Access Compliance Report

Public Rights-of-Way

Intersection ID: 22536	Main Street: PROVIDENCE_RD	Cross Street: SUMMER_TREE_LN	Location: SE
ADA ID: 541D574E3745	Ramp Type: Perp	Initial Pass/Fail: Fail	Overall Compliance: No
Severity Score: 46.25			
Codes/Mitigation Info/Possible Solution		Field Measurements/Component Compliance

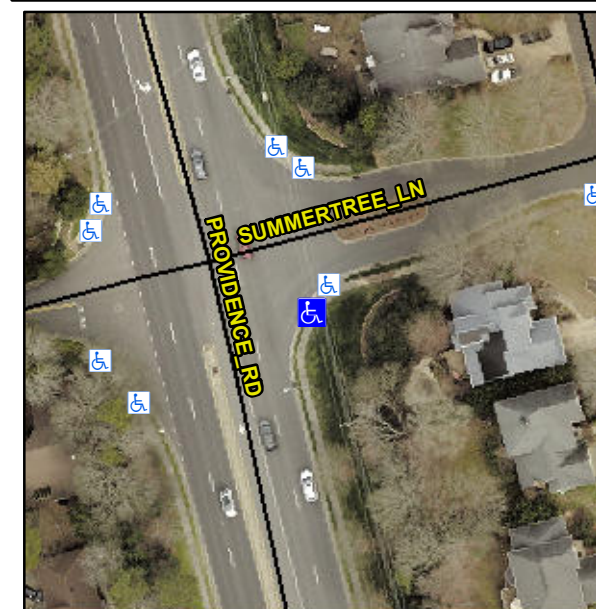
R304.5.1, R304.2.2, R304.5.3

Compliance	Description	Data	Compliance	Description	Data
N/A	Ramp Length (in)	62.0	No	Ramp Slope (%)	10.2
No	Ramp Width (in)	46.0	No	Ramp XSlope (%)	7.4
N/A	Flare Type LT	N/A	N/A	Flare Type RT	N/A
N/A	Flare Slope LT (%)	N/A	N/A	Flare Slope RT (%)	N/A
N/A	Flare Traversable LT?	N/A	N/A	Flare Traversable RT?	N/A
N/A	Landing Length (in)	N/A	N/A	DWS Provided?	N/A
N/A	Landing Width (in)	N/A	N/A	DWS Contrast?	N/A
N/A	Landing Slope (%)	N/A	N/A	DWS Length (in)	N/A
N/A	Landing X Slope (%)	N/A	N/A	DWS Full Width?	N/A
N/A	Landing Curb? (Y/N)	N/A	N/A	DWS Offset (in)	N/A
N/A	Shared Landing?	N/A			
N/A	Gutter Ponding?	N/A	N/A	Gutter Slope (%)	N/A
N/A	Gutter Lip Ht (in)	N/A	N/A	Gutter X Slope (%)	N/A
N/A	Painted X Walk1?	No	N/A	Painted X Walk2?	N/A
	X Walk 1 Direction	To W		X Walk 2 Direction	N/A
N/A	X Walk 1 Width (in)	N/A	N/A	X Walk 2 Width (in)	N/A
	X Walk 1 Slope (%)	3.8		X Walk 2 Slope (%)	N/A
	X Walk 1 X Slope (%)	2.5		X Walk 2 X Slope (%)	N/A

Remove & Replace Entire Ramp.
